**Entergy Nuclear Operations, Inc.**  
Pilgrim Nuclear Power Station  
600 Rocky Hill Road  
Plymouth, MA 02360

**SUBJECT:** Entergy Nuclear Operations, Inc.  
Pilgrim Nuclear Power Station  
Docket No. 50-293  
License No. DPR-35

Entergy Response to NRC Request for Additional Information (RAI),  
Pilgrim Proposed License Amendment Request to Modify Technical  
Specification 4.3.4, "Heavy Loads" to Facilitate Dry Storage Handling  
Operations

**LETTER NO:** 2.14.048

**SAFE LOAD PATH**

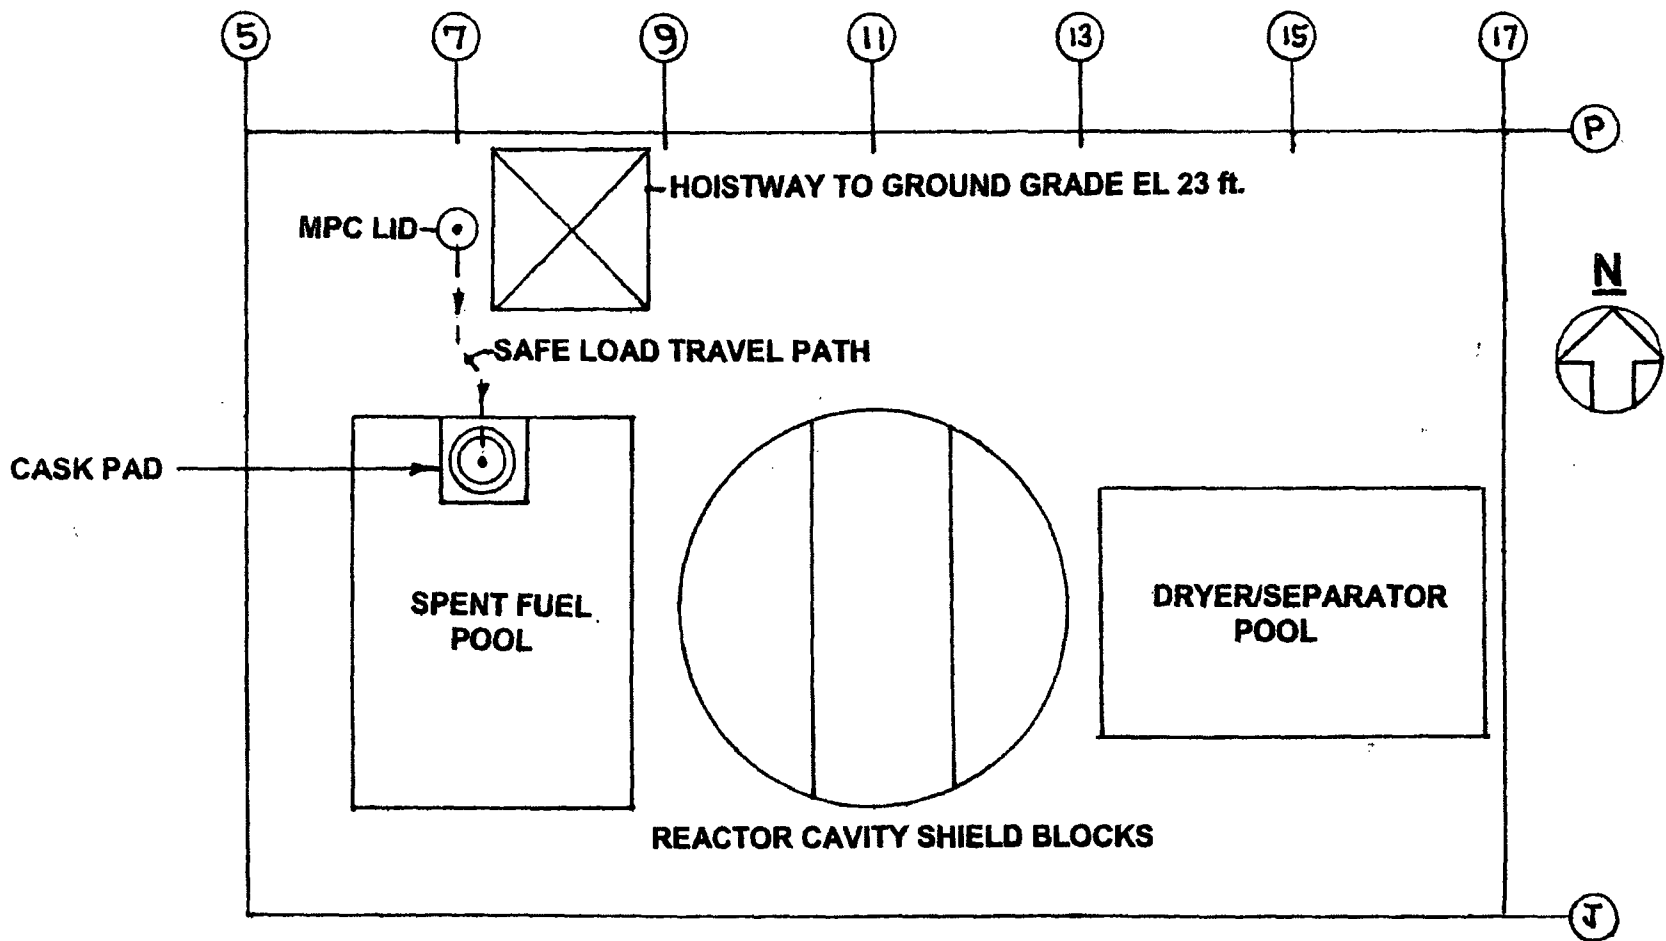
Please provide a simple sketch of the layout showing the arrangements for the Safe Load Path as per NUREG-0612.

The Safe Load Path is shown on Attachment 2 "Safe Load Path" of the Letter. The proposed Safe Load Path meets the NUREG-0612 guidance.
